Memo

Re: BZA-2016-04, Revised McCullough-Hyde Donor Sign

Donor Sign Resubmittal

SIGN TYPE: DONOR SIGN VIEWING DISTANCE

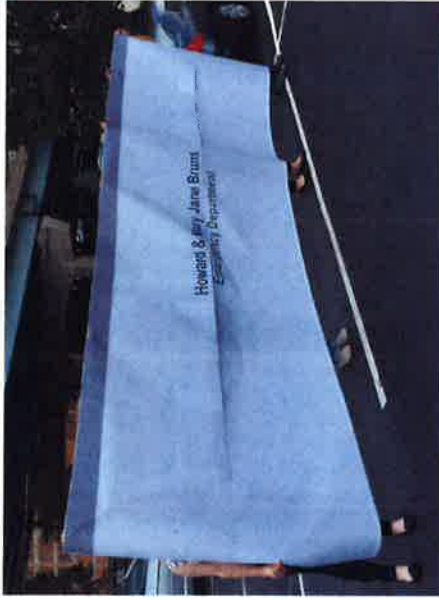
One question from the June hearing was how far is it from the canopy to the street and sidewalk? Mr. Murphy submitted a drawing showing it is 37 feet from the street. Staff included an excerpt from the construction plans showing that the canopy is 25 feet from the sidewalk/property line. The minimum front yard / setback requirement in this location is 16.5 feet. Therefore the canopy location is in compliance.
